**California Regional Water Quality Control Board  
North Coast Region**

**Revised Water Code Section 13267 Investigative Order R1-2022-0025**

**Directing Kernen Construction (Operator/Discharger)**

**Stormwater Discharges from its Glendale Yard to Waters of the State**

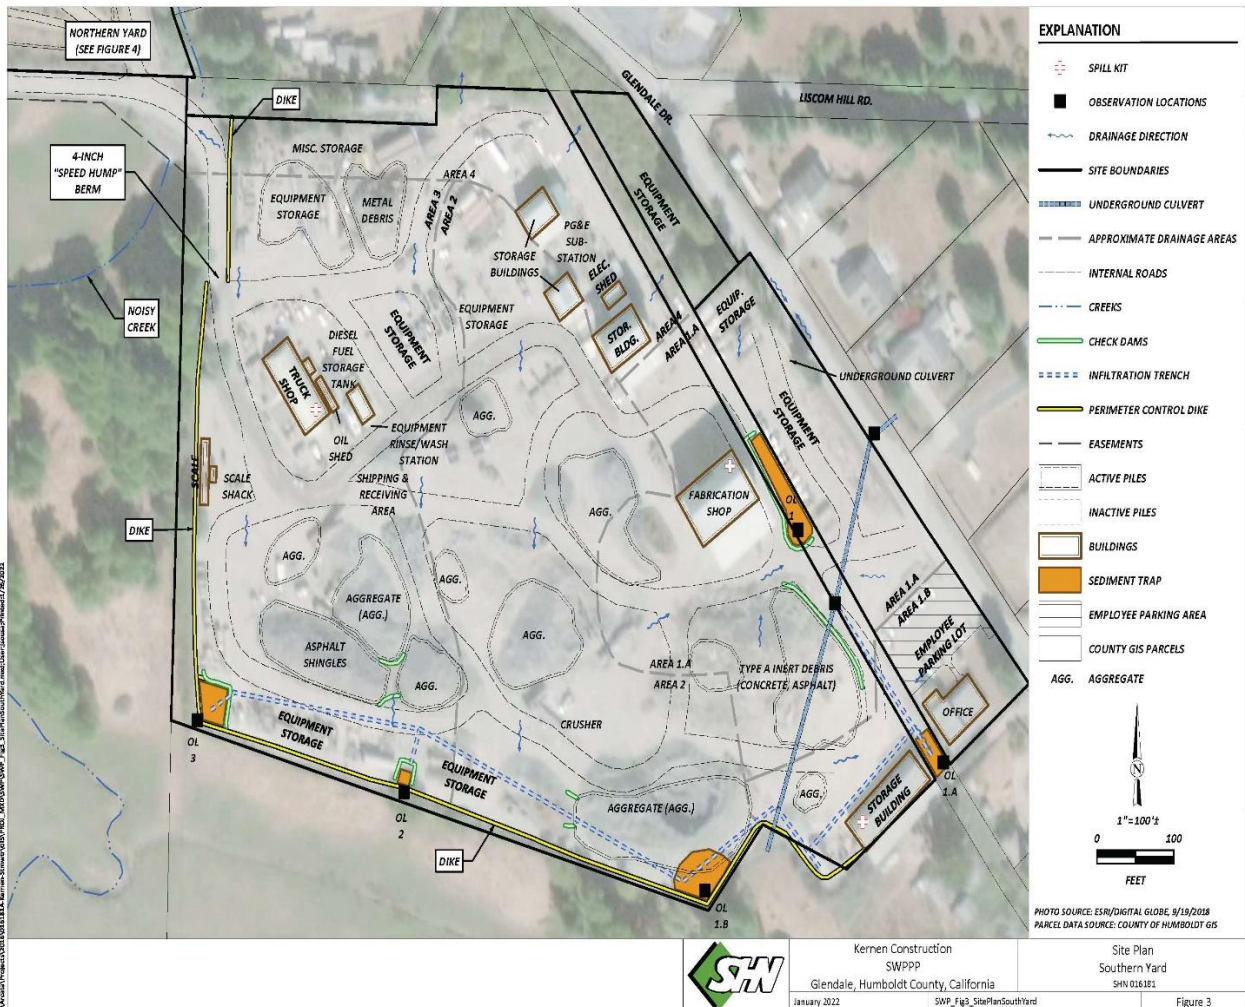
Site map 1. Uploaded site map in SMARTS prepared by the Kern Construction consultant that indicates drainage areas within the upper yard and the receiving water locations that receive runoff from both yards. Note that the parcel labeled 516-151-007, is incorrectly labeled and is actually APN 516-151-008 per County Assessor records available through LandVision.
